TECHNICAL BULLETIN
Bell Helicopter **TEXTRON**

No. 222U-02-94

MODEL AFFECTED: 222U

SUBJECT: TRANSMISSION TOP CASE BUSHINGS P/N 222-040-326-101, REPLACEMENT OF

FIGURE 2
BUSHING REMOVAL / INSTALLATION

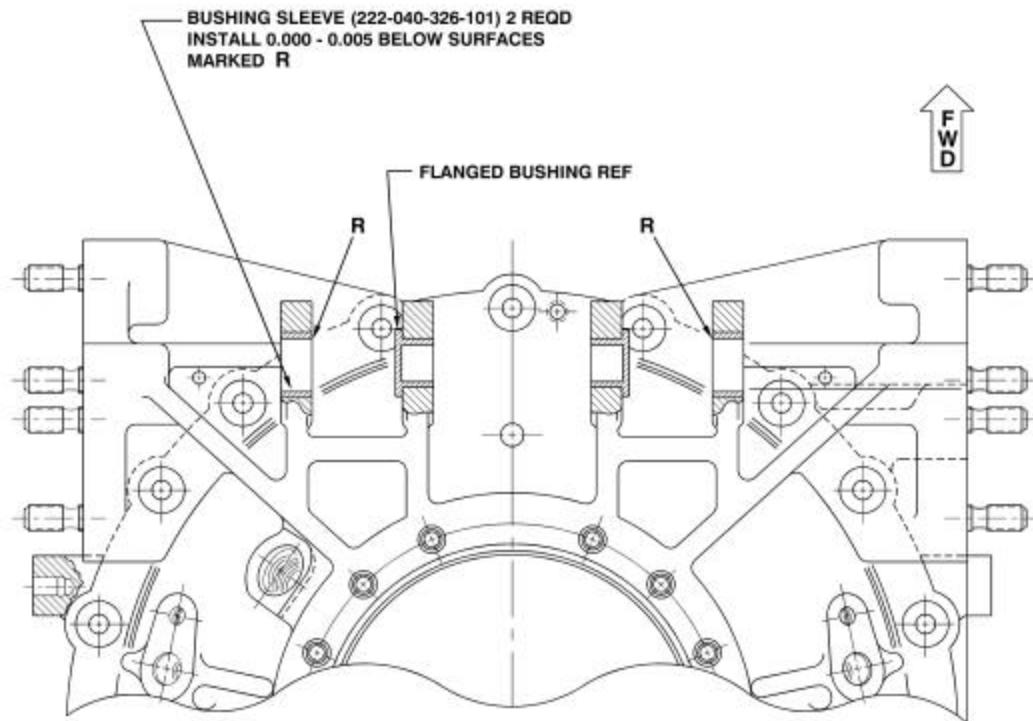
2. Remove the existing sleeve bushing using the P/N T103416-103 replacement set as shown in Figure 2, Detail A.
3. Visually inspect the lug for obvious damage. Bushing hole should measure 1.063 inches maximum. Do a Liquid penetrant Inspection of the hole per BHT-ALL-SPM.
4. Install new sleeve bushing as follows:

- a. Thermo fit new bushing P/N 222-040-326-101 into the lug per BHT-ALL-SPM using P/N T103416-103 replacement set as shown in Figure 2, Detail B.
- b. Install the bushing .000 - .005 inches below the inboard surface face of the lug as noted in Figure 1. Allow primer to dry.

FIGURE 1
TRANSMISSION TOP CASE

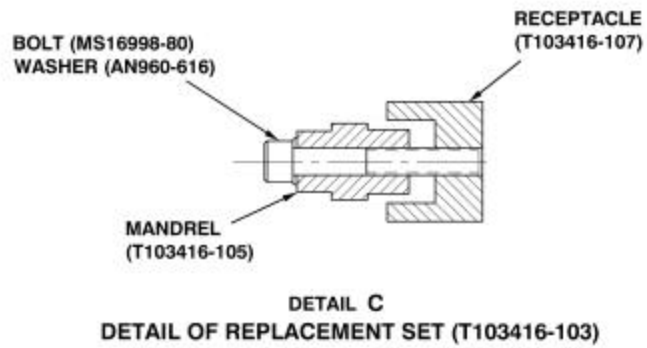
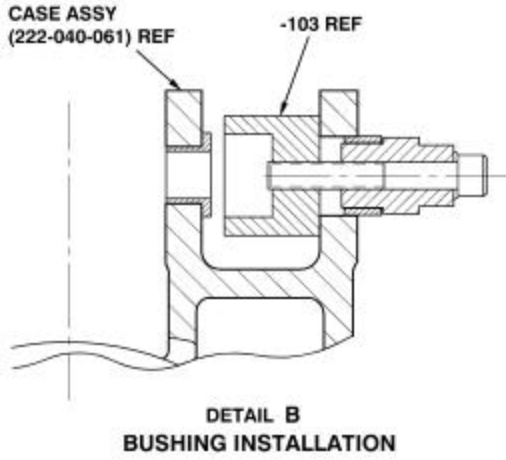
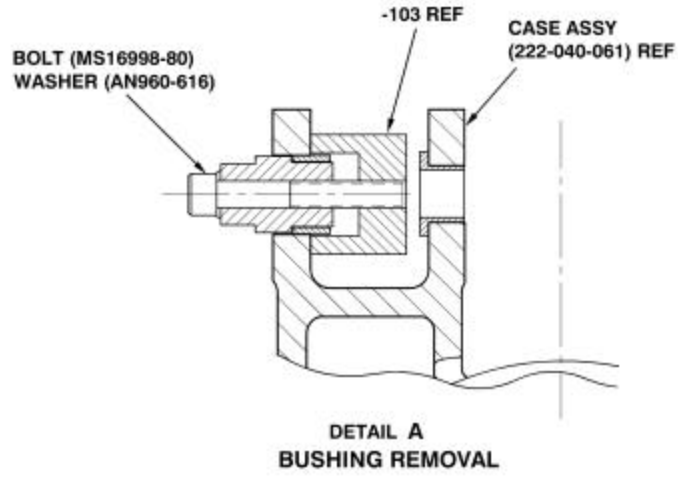
This procedure details the replacement of the P/N 222-040-326-101 sleeve bushings (Figure 1) installed in the top case assembly, P/N 222-040-061-105.

FIGURE 3
TOOL APPLICATION

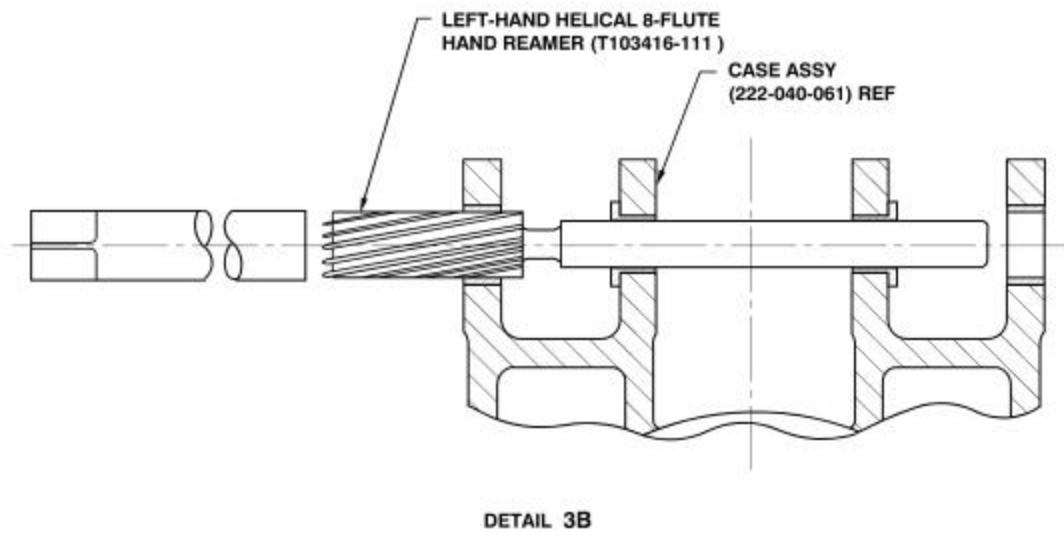
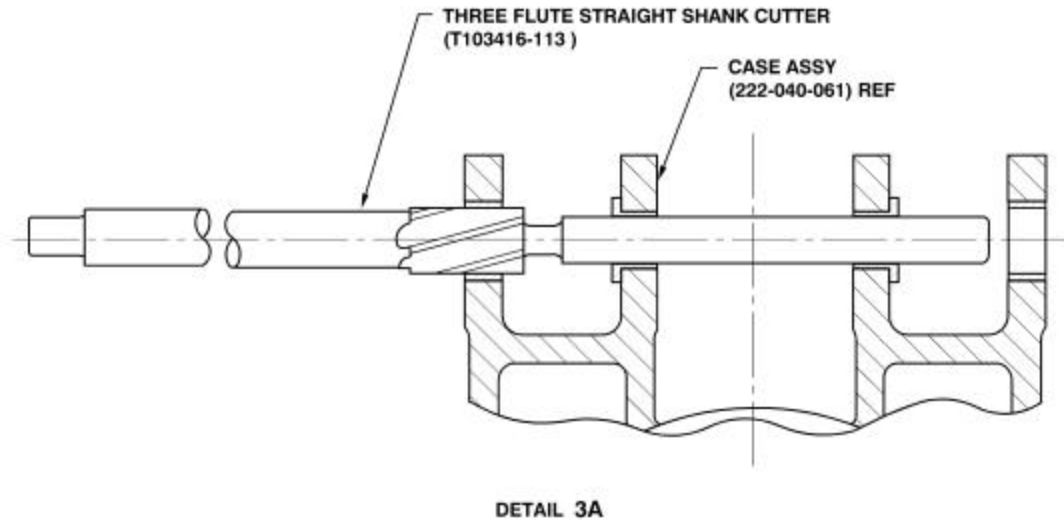
5. Using the three flute straight shank cutter, P/N T103416-113, slowly make one cut through the bushing. Use a suitable lightweight lubricating oil to assure a smooth cut. Refer to Figure 3, Detail 3A.
6. Remove the cutter, clean the bushing bore, removing any metal chips or shaving.
7. Final ream bushing(s) to 0.8750-0.8754 inch using the left-hand helical 8-flute hand reamer, P/N T103416-111. Use a suitable lightweight lubricating oil to assure a smooth cut. Refer to Figure 3, Detail 3B.
8. Remove the cutter and clean the bushing bore, removing any metal chips or shaving.
9. Inspect bushing I.D. in three places. Dimensions must be 0.8750-0.8754 inch.
10. Install all parts previously removed and reconnect idler link assembly P/N 222-010-409-105. Refer to BHT-222U-MM-6.
11. Annotate aircraft records to reflect compliance with this bulletin.
